2.4 CONSENTED ILLUSTRATIVE SCALE AND MASSING

3.2 CONSULTATION TIMELINE

3.3 CONSULTATION

3.3.3 London Borough of Hillingdon - Pre-app 3 - 24th March 2023

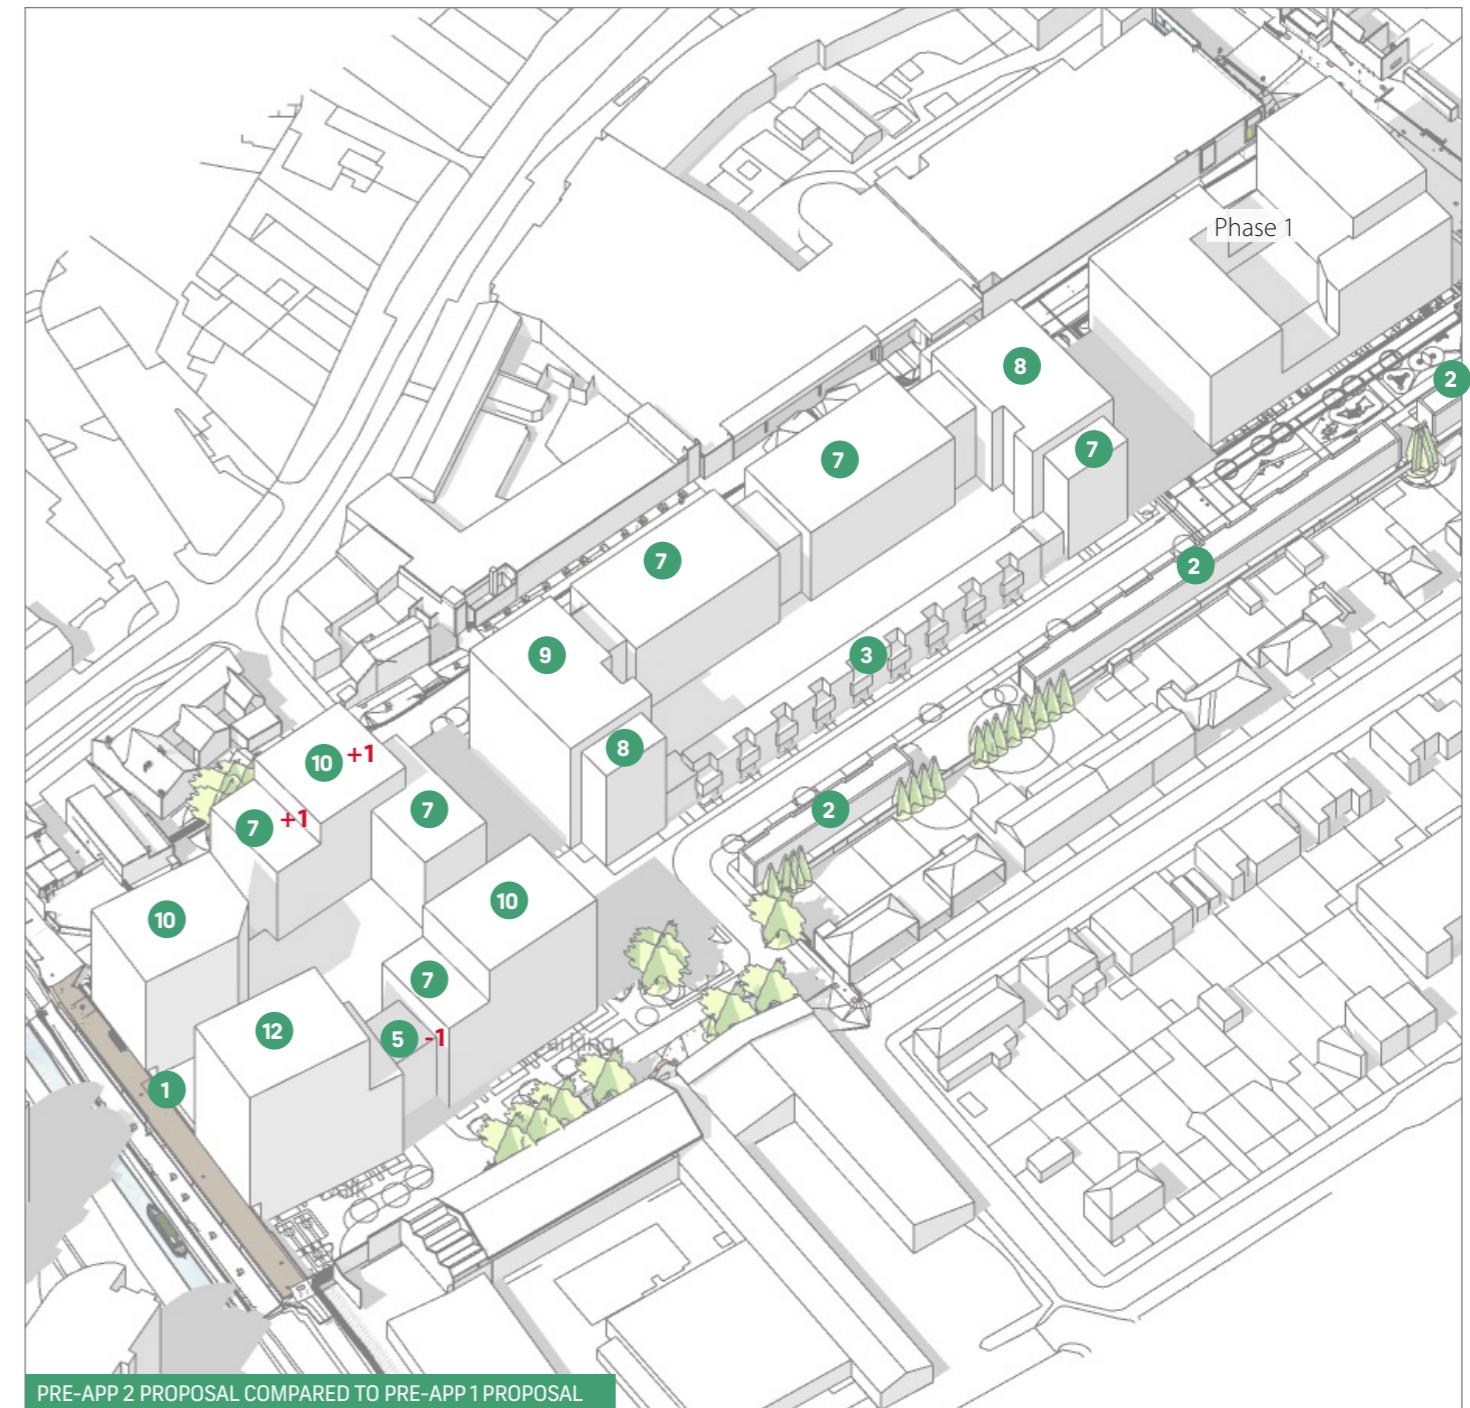
- Phase 4 building heights reduced due to the comments received from pre-app 02: "P4 height to be reduced. Depart from 3no 10 storey approach and create height variation. Explore redistribution of massing particular on northeastern corner of Phase 4 to address overshadowing of new square"
- Added 2nd stair to the 12th building in phase 4
- Building line set back from the canal

The changes resulted in a considerable loss of dwellings and this was discussed during the meeting. It was agreed additional height may be possible in certain locations, but shoulders should be introduced to the canalside and the community square and that this lowered edge should be reflected in the parameter plans as well as the illustrative masterplan.

3.3.5 London Borough of Hillingdon - Pre-app 4 - 19th August 2024

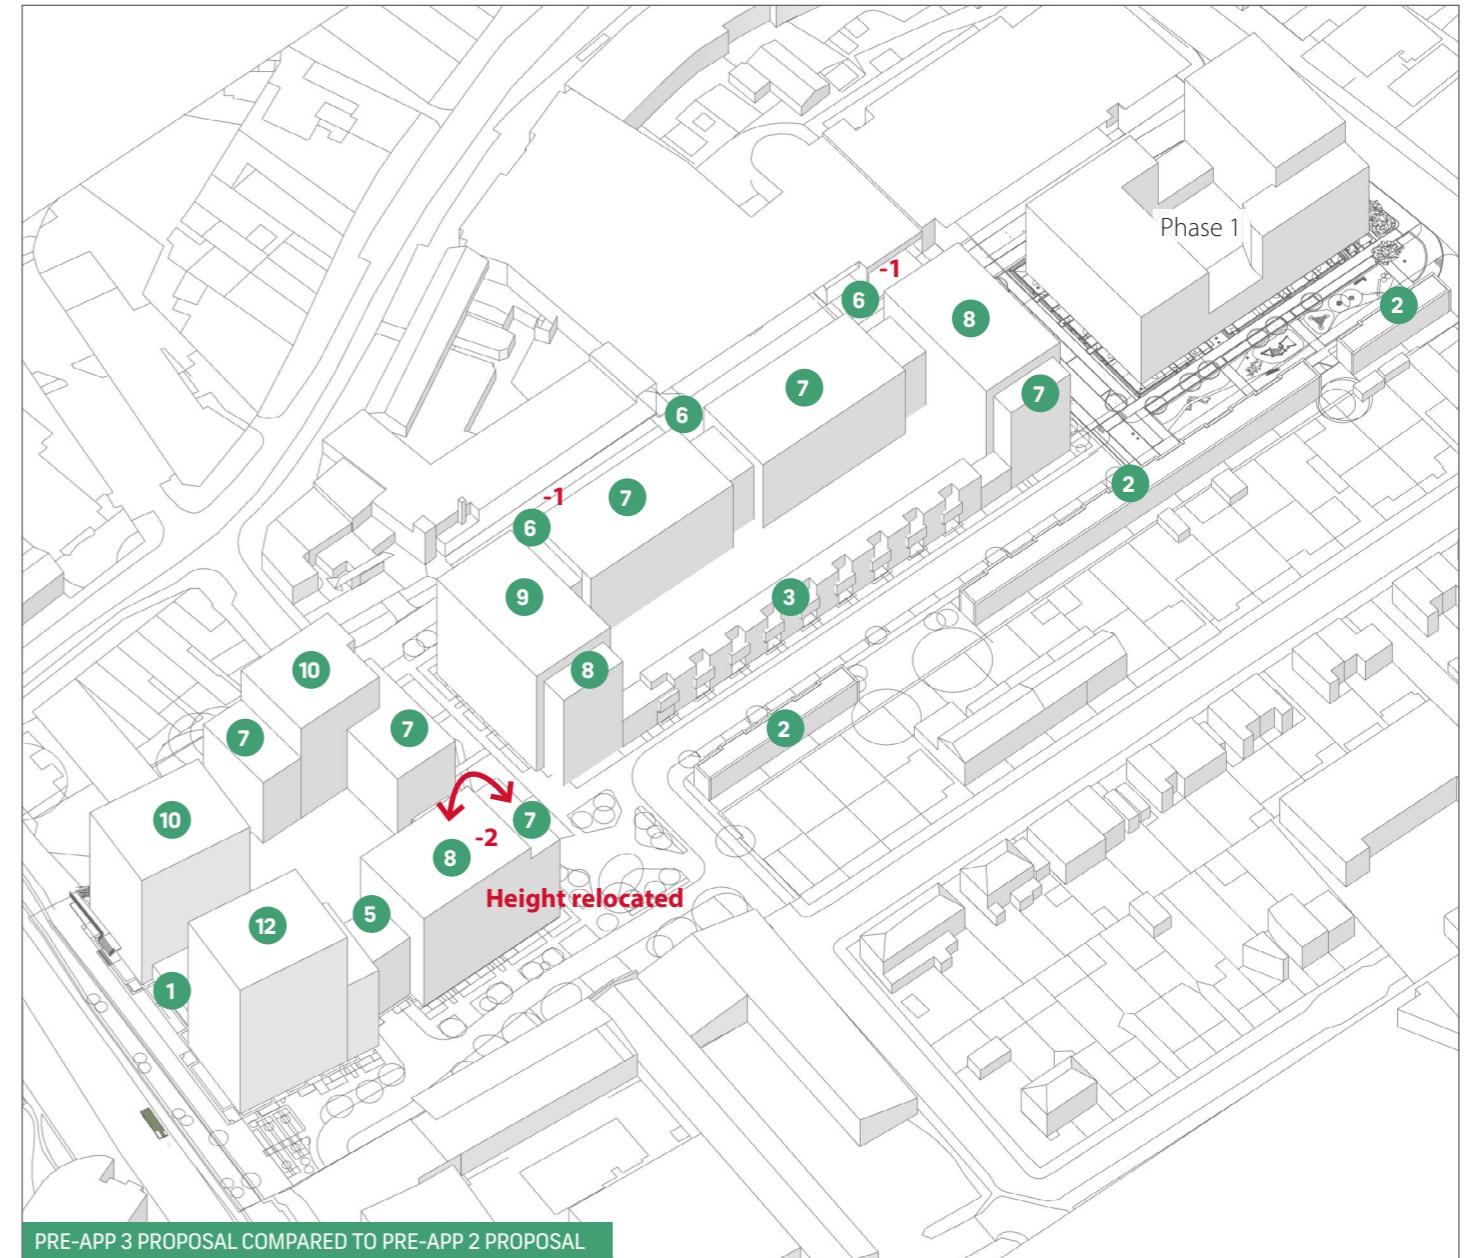
- Agreed there is scope to increase density and massing for the Austin Road proposal
- Phase 4 next to canal has the greatest potential to increase heights
- 9-storey (possibly with 7-storey shoulders) to 15/16 storeys building in phase 4 could probably be accommodated within the amended scheme, and justified in the planning balance.
- Make sure the buildings next to canal are parallel to the canal.
- One additional floor setback from the edge along Crown Close in Phase 2-3 have fairly limited impact.

- A standard residential floor-to-ceiling height for community centre would not be appropriate.

- Improve the access between development and the towpath

3.3.6 London Borough of Hillingdon - Pre-app 5 - 23rd July 2025

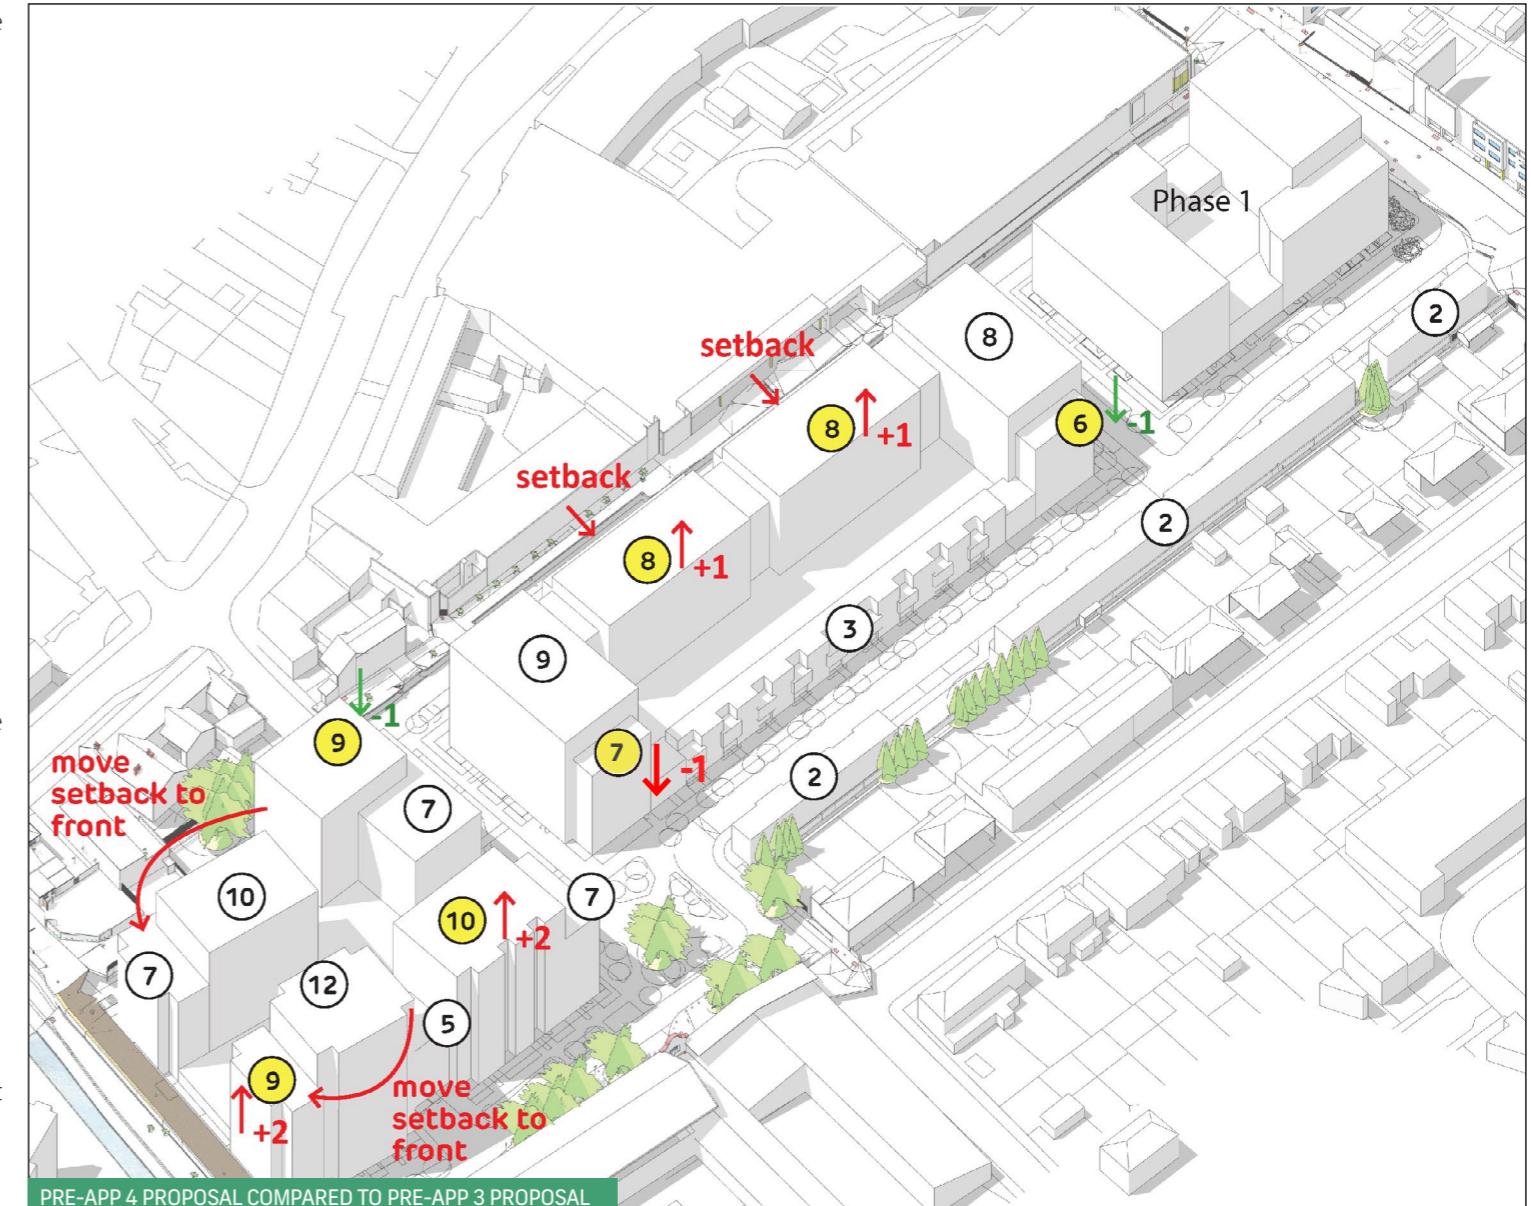
- The proposed duplex units towards the south side of the site are acceptable. The quality of the proposed residential accommodation for these units should be tested further
- The proposed elevations should be reviewed in detail. The principle of a defined base, middle element and top floor elements should be considered to reduce the sense of massing.

- Further details and scaled drawings that show elevational treatments, refuse collection points, servicing arrangements and emergency routes should be provided

- A microclimate assessment should be reviewed in due course, such as wind and overshadowing.
- The proposal should therefore resolve the changes in ground level through design and a comprehensive landscaping strategy, that secures pedestrian movements and permeability, particularly along Silverdale Road

- The approved 'community square' should be reinforced as a way to open movements towards the canal from Austin Road.
- The location of the 'community centre' is therefore supported

- A landscape-led design approach that softens any perception of building height should also be reinforced, particularly at Crown Close and Silverdale Road

- The option to re-locate the proposed entrance fronting the pedestrian link between Blocks 2 and 3 should be considered, to ensure that all the entrances towards the north side of the site are consistently distributed along Crown Close with a clear perception of street hierarchy.

- Overall massing along Silverdale Road requires further review, as this change should also acknowledge forthcoming developments towards the south side of the site and any perception of a narrow and uninviting street should be avoided

- Whilst the proposed public square is accepted, concerns over the quality of this communal amenity space should be noted, particularly by reason of overshadowing and limited floor area.

- A sunlight and daylight assessment would be required for all dwellings, albeit specific concern with the above is noted
- The quality of the residential accommodation for the proposed duplex units along both sides of Austin Road should be reviewed.
- The separation distance between habitable windows would appear acceptable
- The units at first floor level overlooking the podiums should contain defensible spaces, considering that these windows would be directly overlooked by the communal amenity areas
- Details of wheelchair accessible units should be provided

- Car Parking Management Scheme and Transport Assessment would be required for further review
- No details of cycle parking stores for the different building elements have been presented at this stage but these should be conceived to meet regional standards
- In terms of refuse, waste collection distances between a designated bin store and a refuse vehicle should not exceed 10m to comply with waste collection standards (with carrying distances from each residential unit to a storage area not exceeding a distance of 30 metres)

3.3.8 London Borough of Hillingdon - Pre-app 6 - 29th August 2025

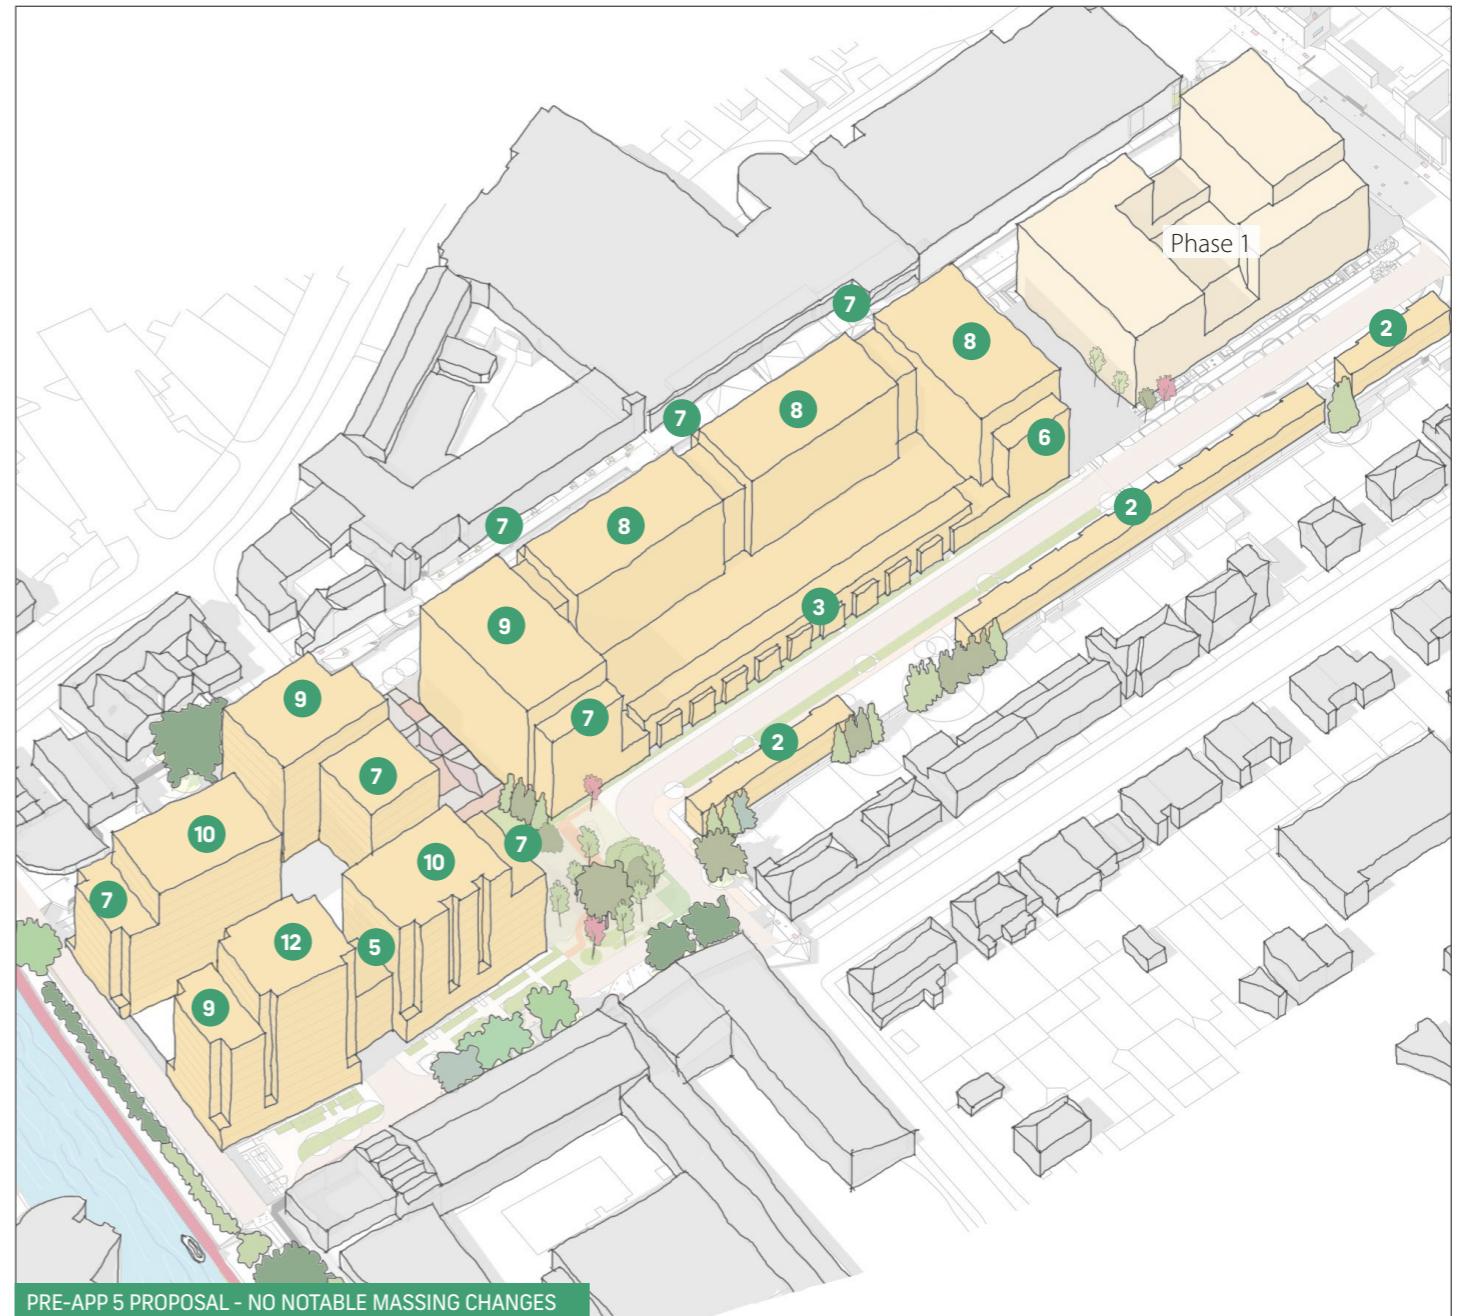
- Update on Phase 4 buildings facing the canal is a positive change and reduces the overall bulk of the buildings, where viewed from the Canal and Hayes Town Centre. The trade off in massing has been achieved by transferring the floor space to the central Phase 3 block, and whilst this has added height to the building, the additional floor has been recessed and does not appear harmful in design terms.

- The Phase 2 houses are supported in principle and are an efficient use of space – further detail needed.
- Whilst the preference would be to provide a higher percentage of dual aspect units, it is noted that the dual aspect percentage has increased compared with the consented scheme and could be accepted on this basis.

- Works within the Canalside area will need to consider proposals currently in development for enhancing this space. These works may progress in advance of Phase 4 of the development.

- The access ramp arrangements are convoluted and overly engineered, to be reviewed to provide a more practical and straightforward route.
- Planning application 71374/APP/2016/4027 on the adjoining site to the east was granted approval in July 2019 and has expired. Whilst the approved plans showed access being provided into this site via Silverdale Road through the development site, this would be a suboptimal arrangement

- The extent of public open space will need to be clarified in terms of sqm area. There is an increase in residents compared with the consented scheme so a comparison is needed in terms of the delivery of open space, ideally an uplift in the quantity of public open space would be expected.

- It is positive that the UGF target of 0.4 is exceeded, although this is marginal and a further increase in greening is encouraged to ensure that this can be more comfortably achieved.

- Play provision calculation needs to be clearer and must not include more general areas of public realm, private amenity, or access paths/roads.
- The boundaries between Phases 3 and 4 could be more coherent and the delivery of a larger part of the public open space and children's play area, which sits between Phases 3 and 4 on the Phasing Plan could be implemented at Phase 3 to allow the residents and the public access to these spaces.

- Clarification is required on affordable housing provision across the site as a percentage by habitable room.
- Car-free approach to phase 4 was well-received.
